**OPERABLE UNIT ONE COMPLEX  
IMPLEMENTATION PLAN**

**DOCUMENT NUMBER 15000-PL-0001 (REV. 0) PCN1**

**PAGE CHANGES**

## **OPERABLE UNIT 1 COMPLEX IMPLEMENTATION PLAN FOR ABOVE-GRADE DECONTAMINATION AND DISMANTLEMENT**

FIGURE 4-1 OU1 Complex Remediation Schedule

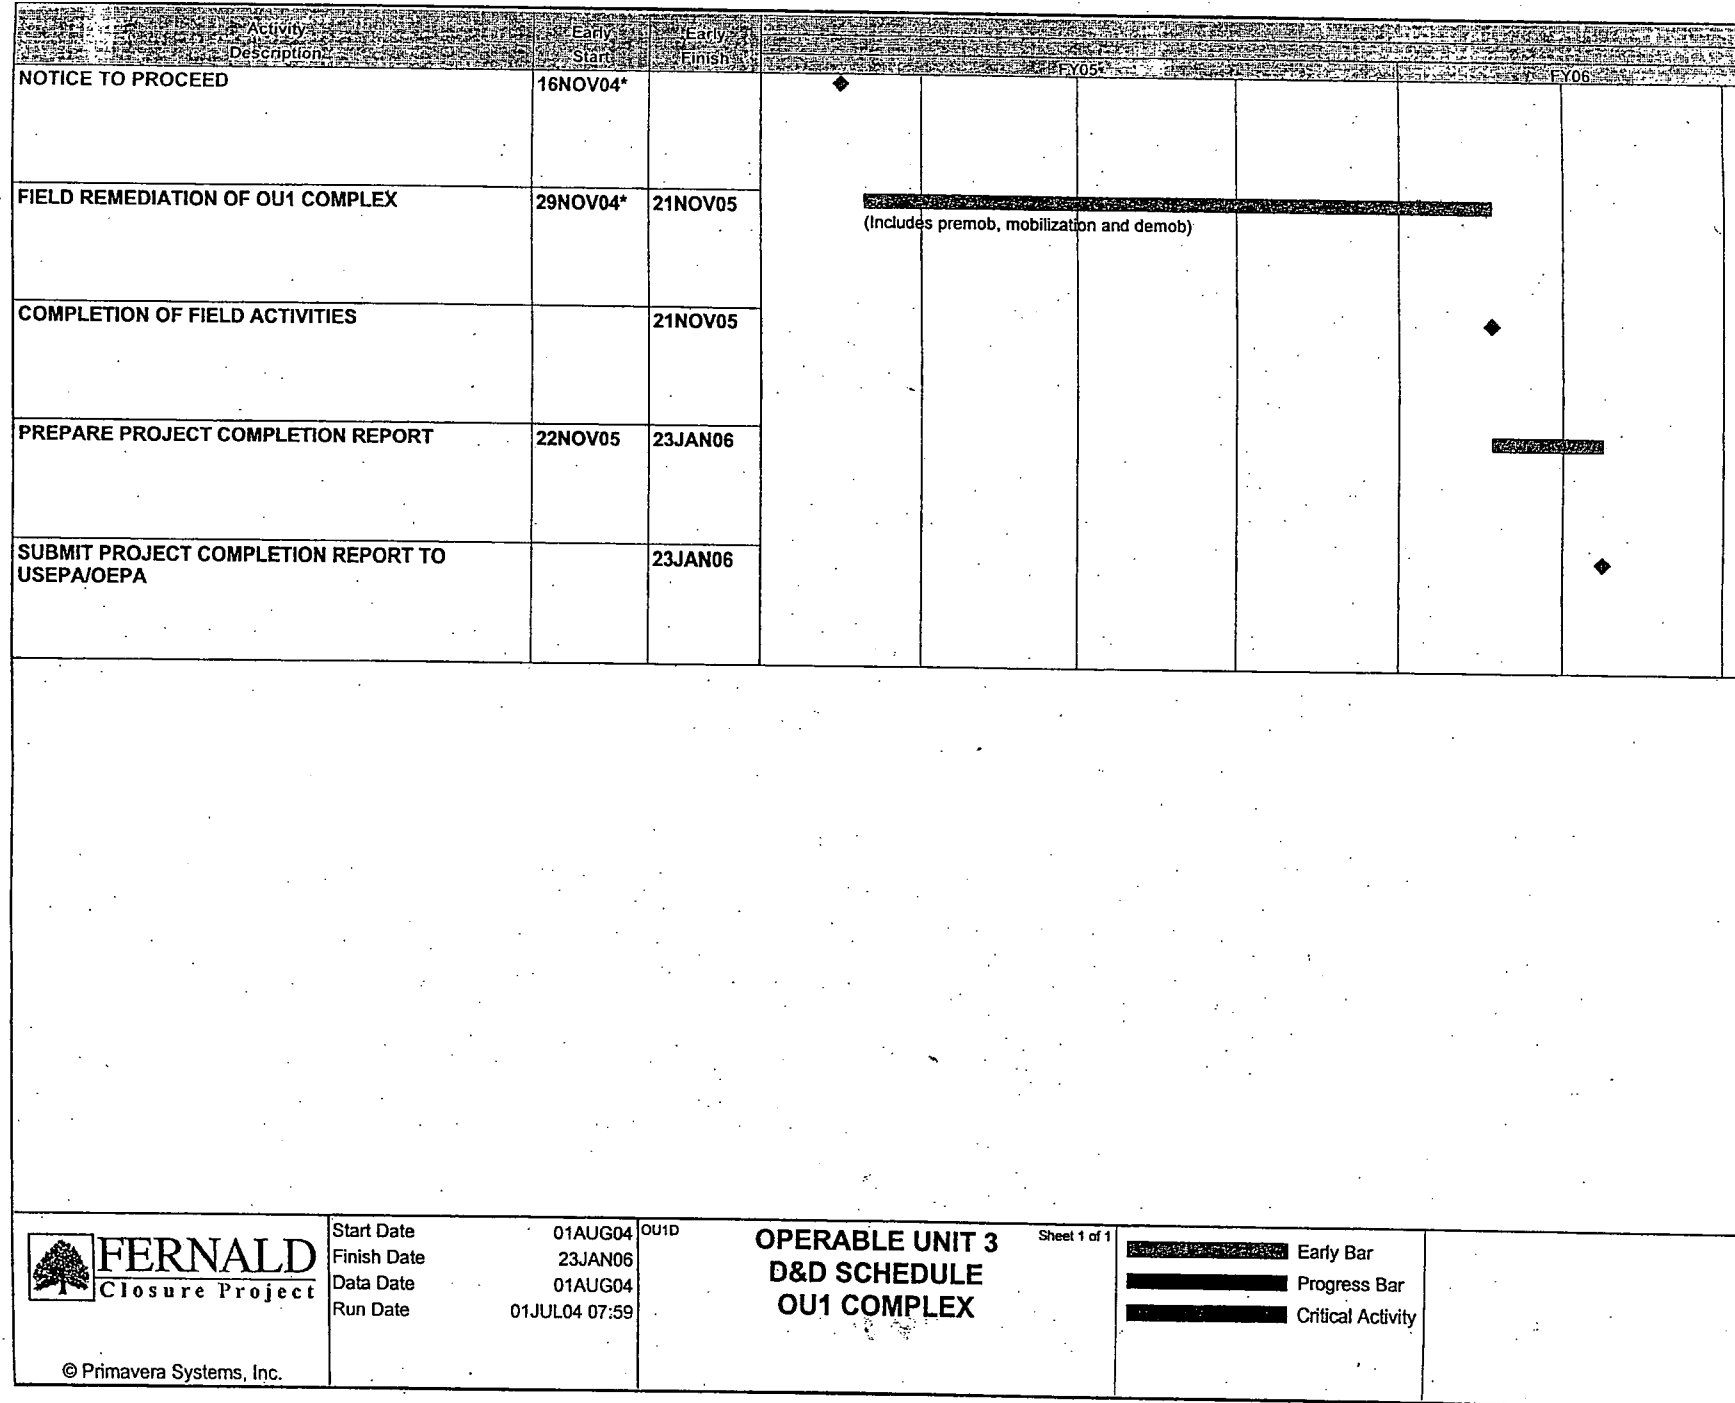
**PAGE 29/30 – FIGURE 4-1**
